CUSTOMER NO.: 24498 PATENT Serial No.: 10/007,157 PU010276

REMARKS

This application has been reviewed in light of the Office Action of April 8, 2004. Claims 1, 3-6 and 8-11 are pending in the application. By the present amendment, claims 1, 6, and 9 have been amended. Claims 2 and 7 have been canceled without prejudice. No new matter has been added. The Examiner's reconsideration of the rejection in view of the amendment and the following remarks is respectfully requested.

Fig. 1

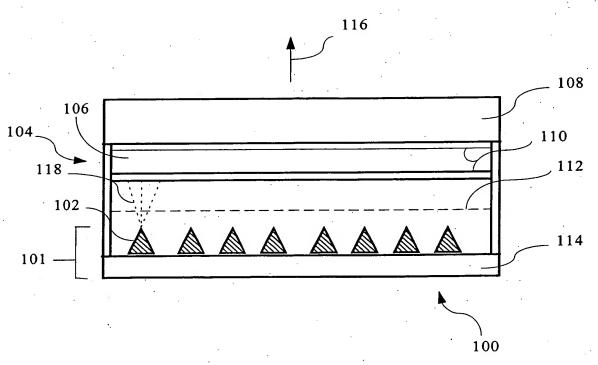
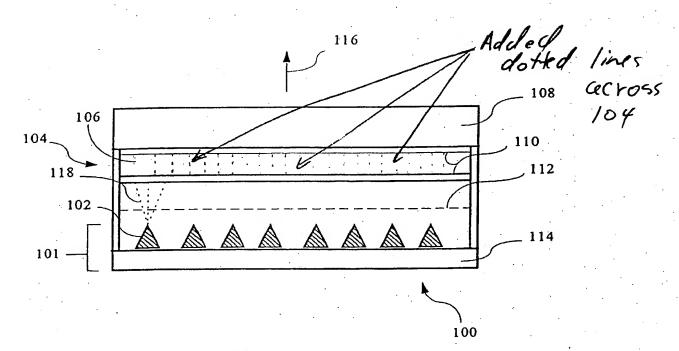
By the Office Action, the Examiner objected to the drawings as not showing every feature as specified in the claims, namely "an array of resonant microcavity anodes" as claimed in claim 6. The Applicants respectfully disagree with the rejection.

FIG. 1 shows a microcavity anode 104 for a resonant microcavity anode (RMA) type field emission display (FED) device. The array of anodes is included in the layer 104 as can be seen from FIGs. 13a and 13b in U.S. Patent No. 5,804,919 to Jacobsen et al. (hereinafter Jacobson), which was incorporated by reference. FIG. 1 has been amended to show a portion of layer 104 as an array of anodes. Therefore it is respectfully submitted that the claimed feature of "an array of resonant microcavity anodes" is now presented in the FIGS. A new FIG. 1 and a marked-up version are submitted herewith showing dotted lines in anode layer 104 to show an array of anodes. Support is found in Jacobsen as referenced above. No new matter has been added. Reconsideration is respectfully requested.
